# CITY OF ALBUQUERQUE

**Re: Laundromat TI**  
**12910 Indian School Rd NE**  
**30-Day Temporary Certificate of Occupancy**  
**Transportation Development Final Inspection**  
Engineer's/Architect's Stamp dated 8-27-20 (J22D052)  
Certification dated 5-11-21

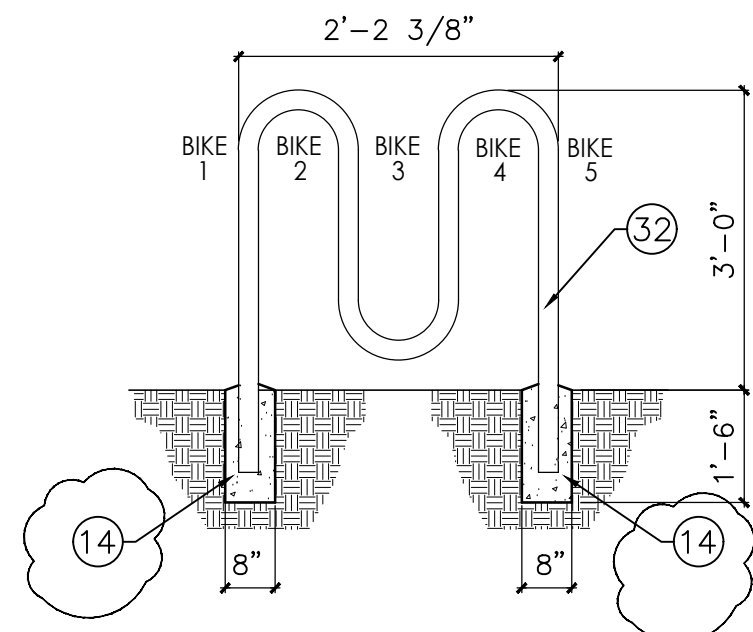
- ADA pathway from public sidewalk to building entrance is not ADA compliant. Please correct. (See attached Photo)

1. The approved and stamped TCL, with changes drawn in red.
2. Transportation Certification letter on either the plan or applicants letterhead.
3. A Drainage Transportation Information Sheet (DTIS)
4. Send an electronic copy of your submittal to [PLNDRS@cabq.gov](mailto:PLNDRS@cabq.gov).
5. The \$75 re-submittal fee for log in and evaluation by Transportation.
